**STAFF REPORT: MARCH 10 2021 MEETING**

**APPLICATION NUMBER: 21-7115**

**ADDRESS: 4138 LINCOLN**

**SCOPE OF WORK: REHABILITATE BUILDING TO INCLUDE REPLACEMENT OF WINDOWS AND FRONT PORCH**

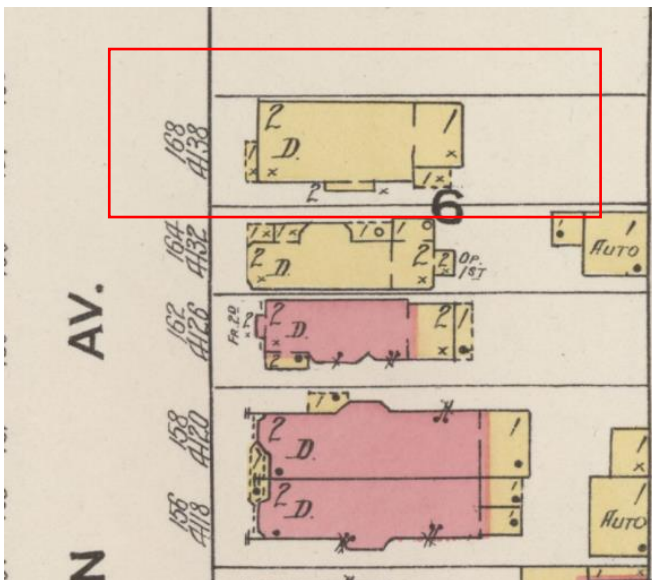
- It is staff's opinion that the front porch is a character-defining feature of the home, despite its deteriorated condition
- The application proposes to replace the front porch because it is deteriorated. However, a field visit to the site and an assessment of the submitted photos revealed that a number of the porch elements appeared to be repairable to include the following:
  - The entire roof/canopy structure to include the roof, wood beadboard ceiling, decorative wood brackets, and structural cornice/beam and corner post
  - The remaining wood balustrade and newel posts

- 2x4 wood posts have been added recently to the front porch in order to provide structural support to the porch. Staff supports their removal and replacement with more appropriate wood columns

- It is staff's opinion that all of the windows and trim/brickmould at the front elevation are character-defining features at the home. Note the decorative top sash at the three windows which are located at the attic story gable end. The applicant has proposed to replace these windows with standard 1/1 wood sash windows. Also, the first and second story windows are topped with transoms. The meeting rails/areas where the bottom rail of the transom meets with top rail of the windows are fairly deep and likely cannot be closely replicated with new windows. Finally, the trim/brickmould and sills at the front elevation windows appear to have more detail than the trim at the side elevations. A review of the submitted documentation revealed that these windows and the associated trim/brickmould and mullions can be retained and repaired.

- The proposed replacement of the windows at the front elevation. In staff's opinion, the windows and associated trim at the front elevation are distinctive character-defining features and should be retained and repaired
- The replacement of the existing front porch. It is staff's opinion that front elevation porch is a distinctive character-defining feature of the home. The most distinctive features of the porch appear to be in repairable condition and should be retained. These elements include the following:
  - The entire roof/canopy structure to include the roof, wood bead board ceiling, decorative wood brackets, and structural cornice/beam and corner post
  - The remaining wood balustrade and newel posts

- The following elements of the front porch shall be retained and repaired where necessary with in kind materials:
  - The entire roof/canopy structure to include the roof, wood bead board ceiling, decorative wood brackets, and structural cornice/beam and corner post
  - The remaining wood balustrade and newel posts
- The existing windows, brickmould/trim, and mullions at the front shall be retained and repaired
- The applicant shall revise their construction drawings to reflect the Commission's conditions. These drawings shall be submitted to HDC staff for review and approval prior to the issuance of the permit

4138 Lincoln St. Renovation  
Window Details

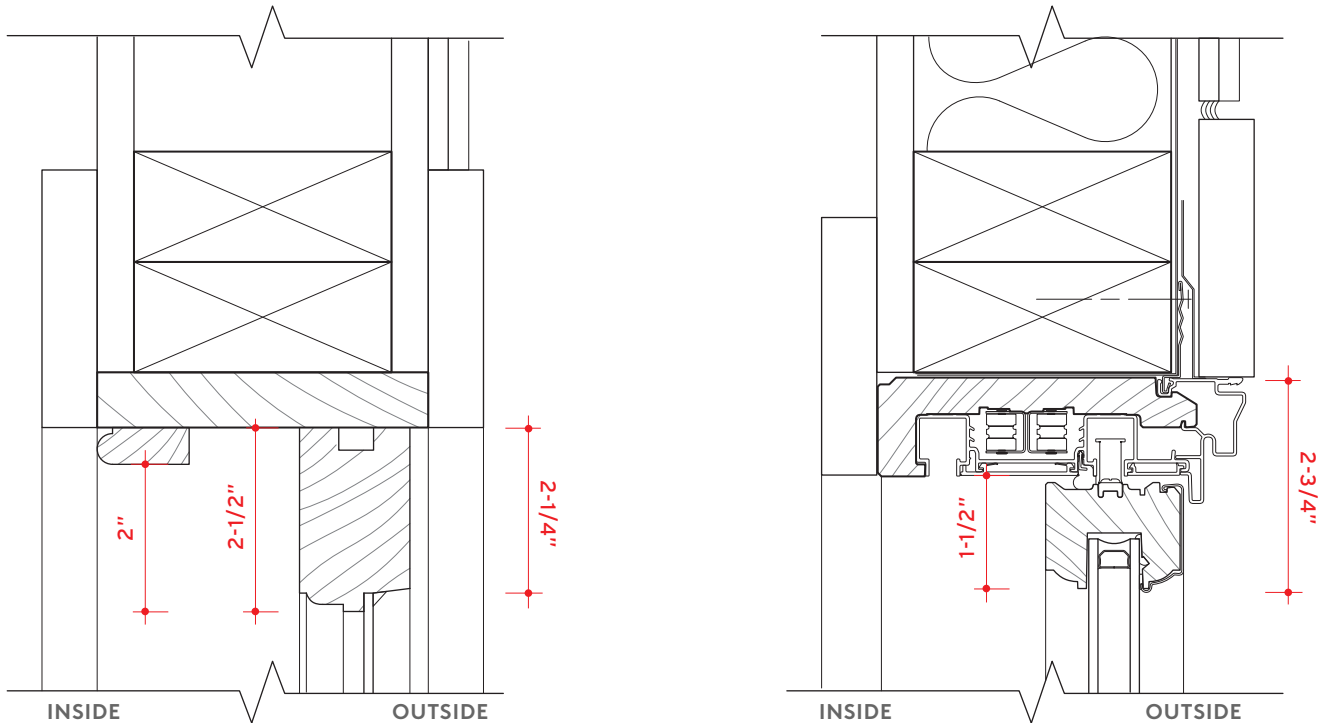
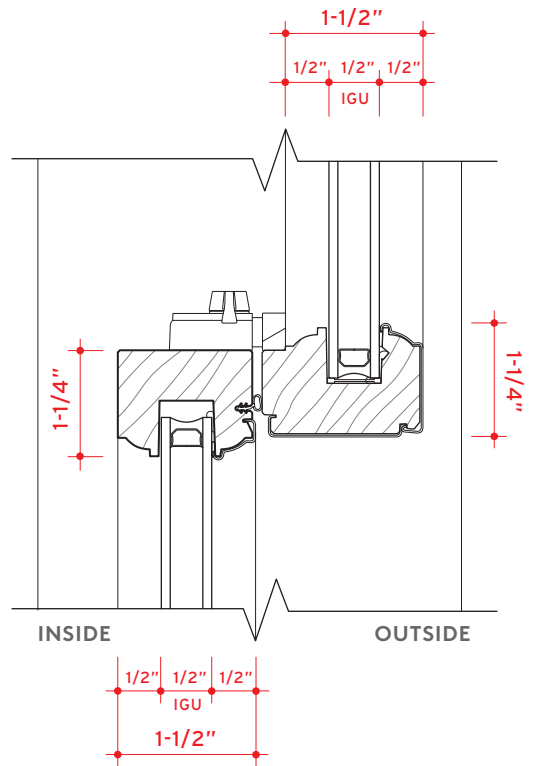
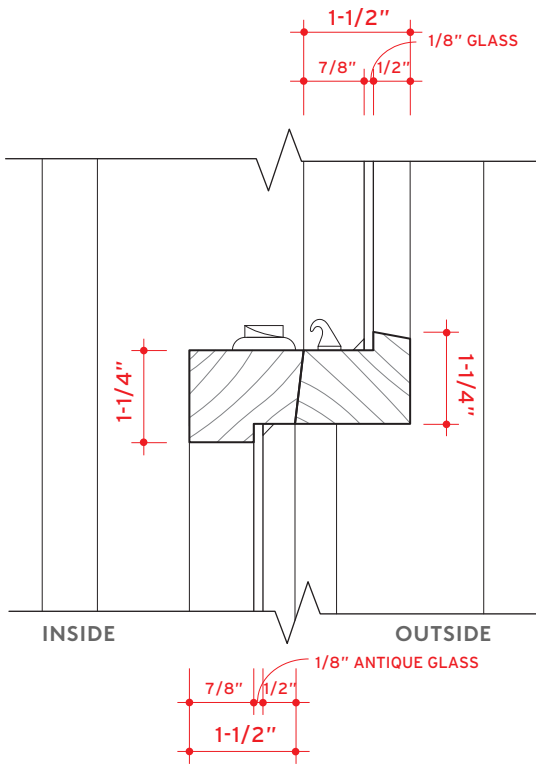
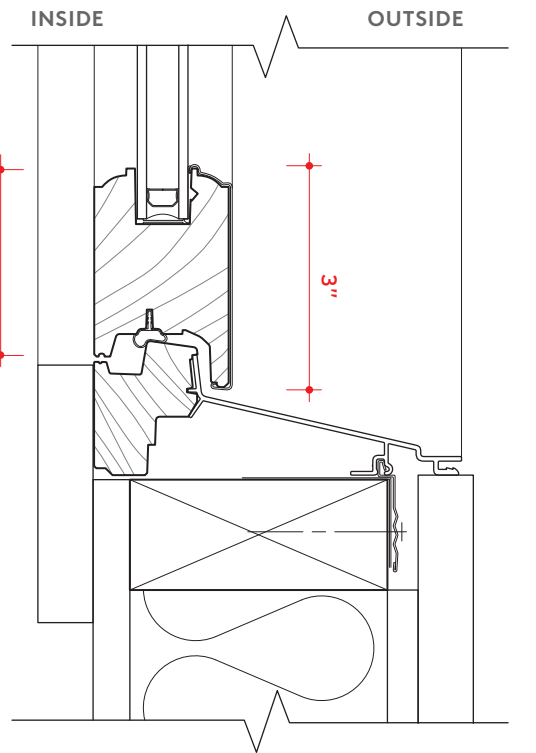
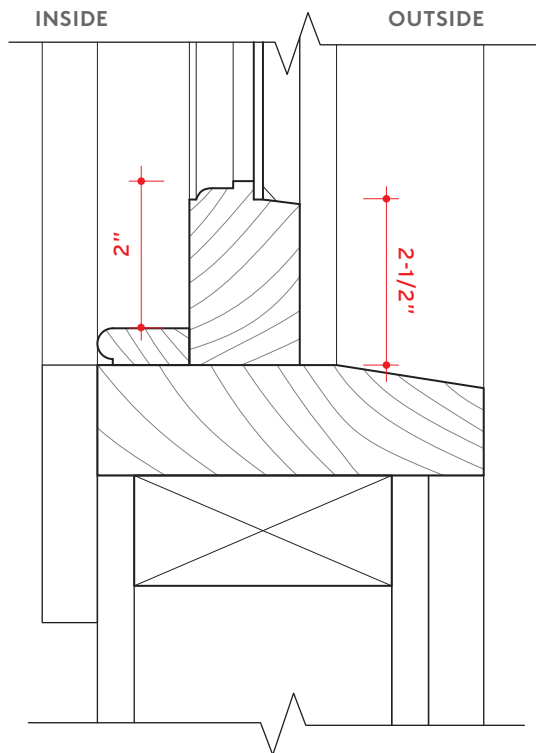
- The side elevation windows are located towards the rear of the each wall and they are 1/1, wood-sash units. The applicant has proposed to retain and restore the windows at the north/side elevation while replacing the brickmould trim and mullions at this elevation. However, the applicant is proposing to replace the windows, brickmould/trim and mullions at the south/side elevation. The windows and brickmould/trim and mullions proposed for replacement at the side elevations are in poor condition, in a non-prominent location, and are generally utilitarian in character. It is staff's opinion that the windows at the side elevation are less significant than those at the front elevation due to their location and relative utilitarian nature.
